CHURCH AT BENT GRASS MEADOWS
SITE DEVELOPMENT PLAN

SITE DEVELOPMENT PLAN
COVER

PCD File No.
PPR2622

PCD FILE NO.: SF268

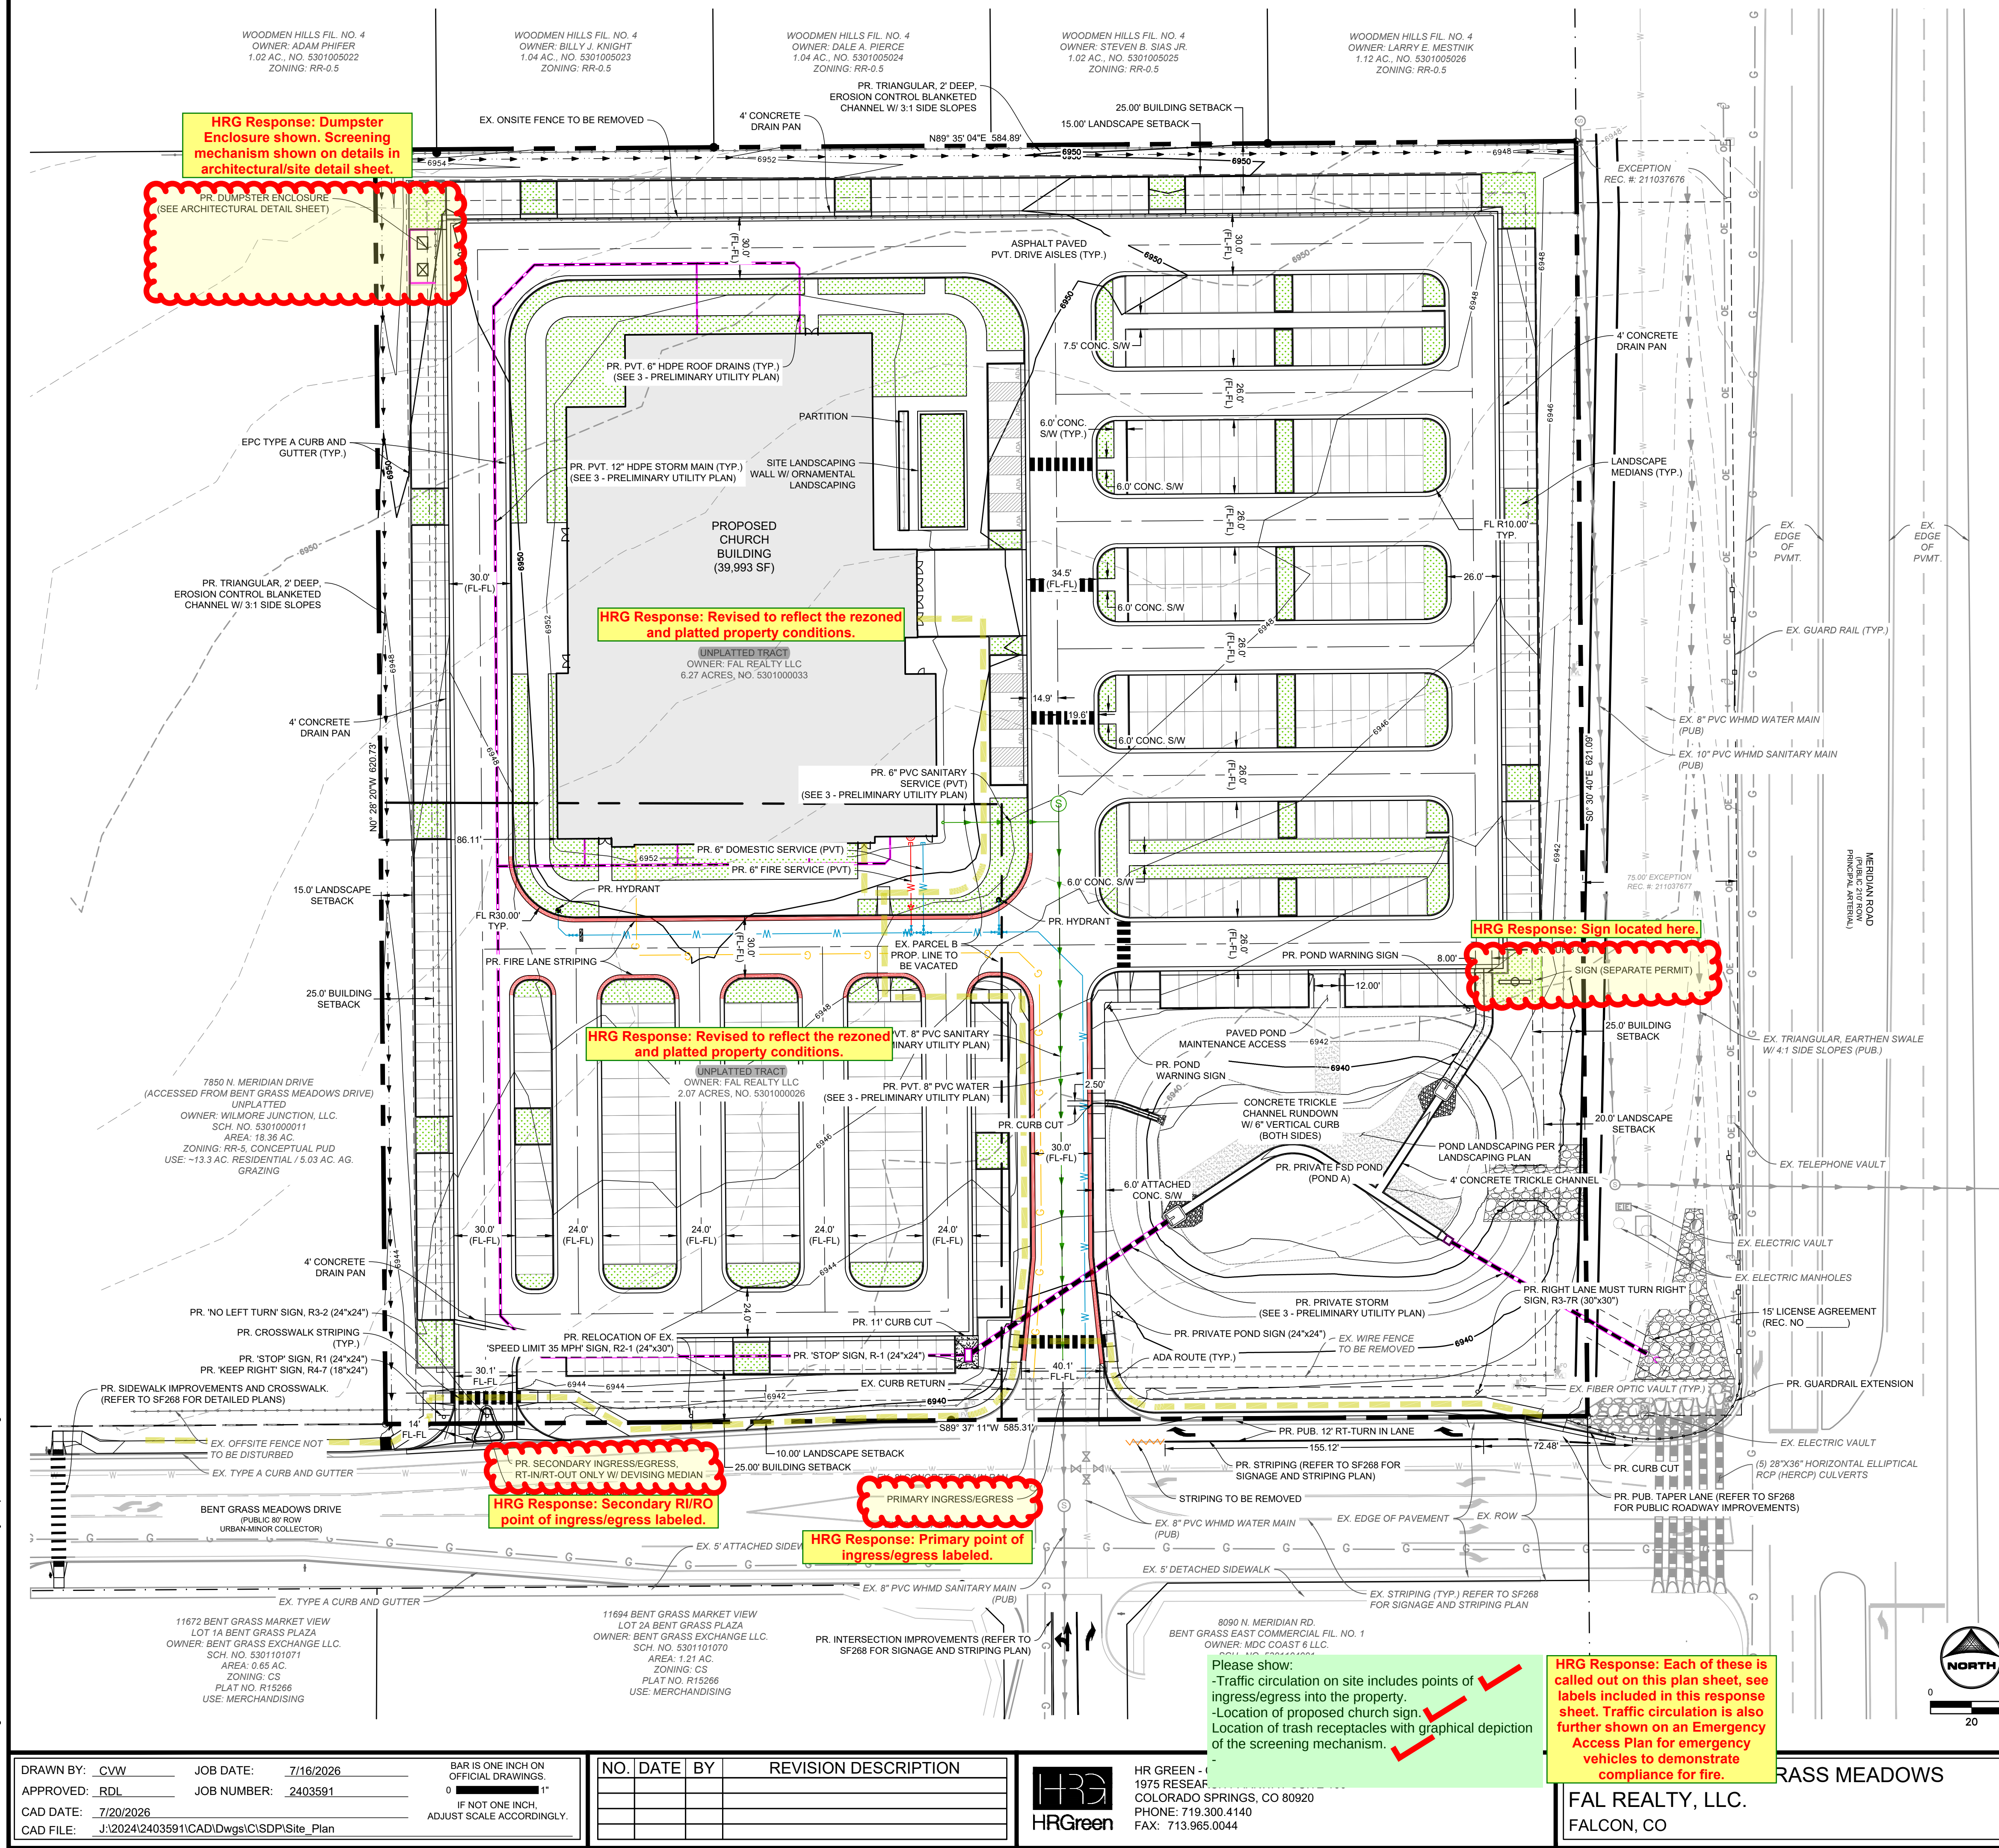
Please revise this site development to be current with the proposed final plat layout.

Please recalculate the parking (LDC Table 6-2 + 6-3.)

HRG Response: Revised to reflect the rezoned and platted property conditions.

HRG Response: Revised as Space:Seats instead of Seats:Parking to be clear and match code, but otherwise it already matches the requirements.

1 EAST ELEVATION
A200 1/8" = 1'-0"

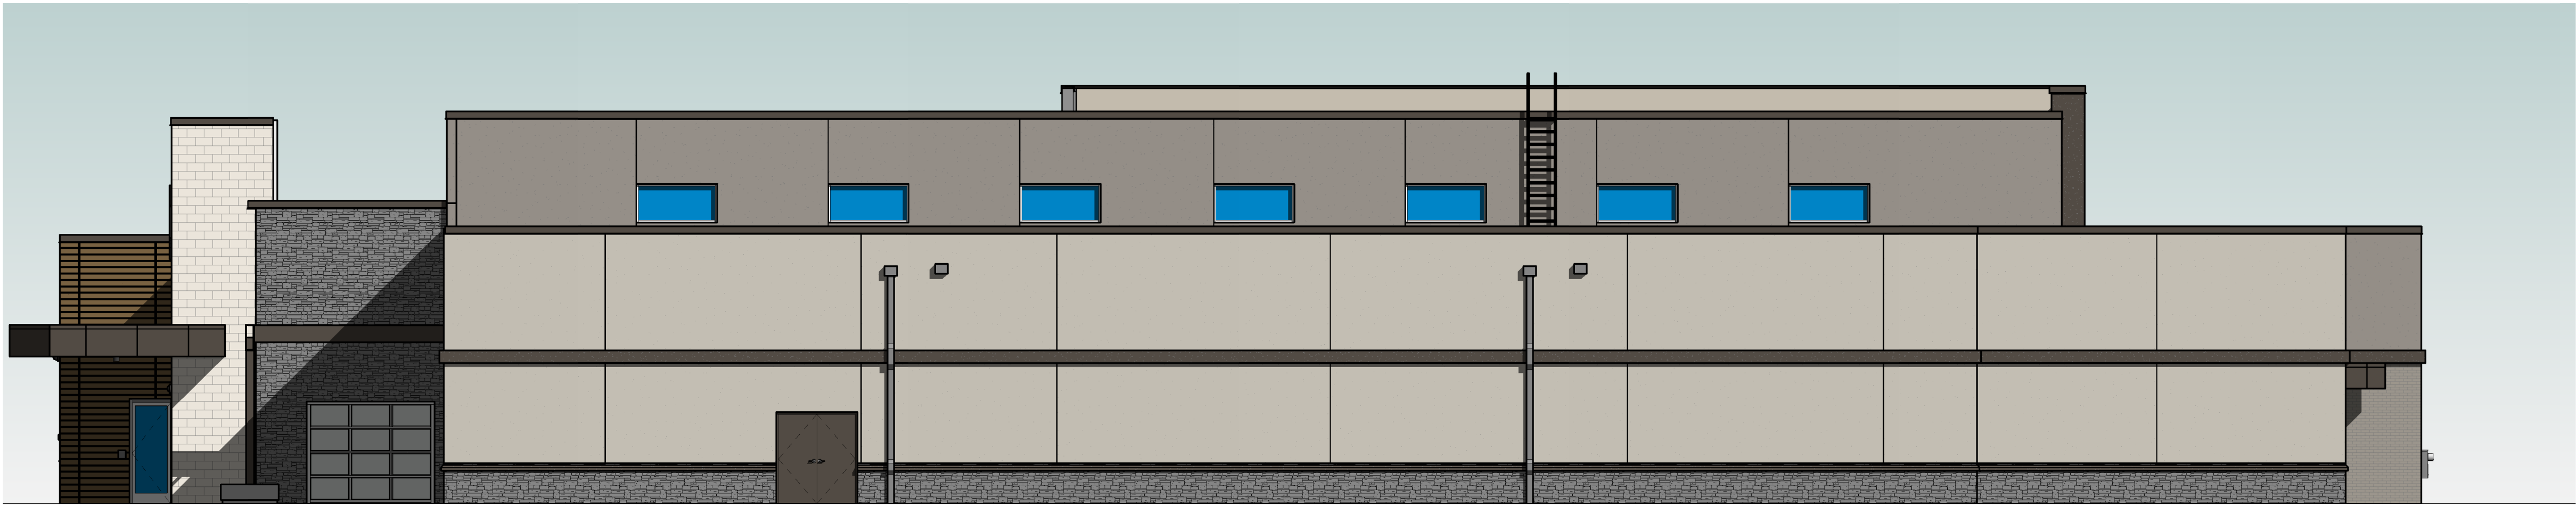
Please add additional elevation information to include structure height, length, width etc.

Full elevation data is required to review sign plan.

FAL Realty Architecture Group Response: Additional information now included with dimensioning.
